TECHNICAL BULLETIN

MODEL/DERIVATIVE:
All Discovery Series II

Bulletin N°: 0019
CDS. ref: L8702bu
Issue: 1
Date: 17.10.01

PROBLEM:
POTENTIAL TYRE / RADIUS ARM FOUL FOLLOWING A STEERING BOX CHANGE

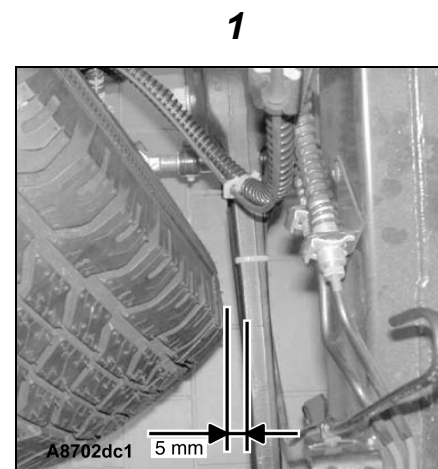
- After a Power Assisted Steering (PAS) box replacement, a foul condition may be experienced between the tyre and radius arm.
- Following a PAS box replacement, the clearance between the front tyres and suspension radius arms must be checked on extremes, of both full left hand and right hand steering lock. Failure to do this may cause the customer to complain of a noise from the front of the vehicle on full steering lock.

1. Turn the steering wheel to left then right full lock, and have an assistant check for clearance each side between the tyre on the inner steered wheel and the radius arm (illustration 1).
2. If the measured clearance on either lock is less than 5mm, then a new lockstop must be fitted.

ACTION:
When a PAS steering box has been replaced, follow the procedure below to check there is sufficient clearance between the tyre and radius arm. If there is not sufficient clearance, replace the lockstop with the new extended length lockstop part number TTE000010 (colour coded blue).

2

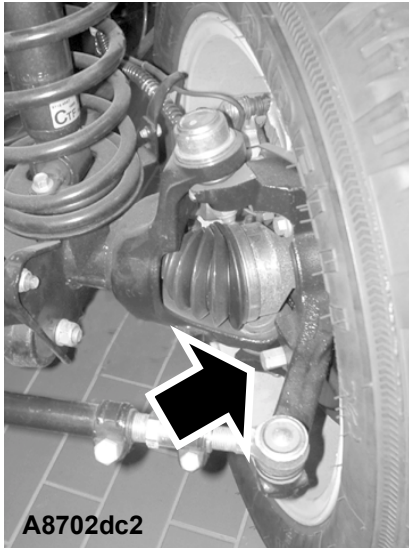
3. Remove the existing lockstop bolt (arrowed in illustration 2).
4. Finger-start the new bolt part number TTE000010.
5. Tighten bolts to a torque of 24 Nm. No additional adhesive is necessary as this is already applied to the bolt.

TTE000010 – Lockstop bolt (colour coded blue)
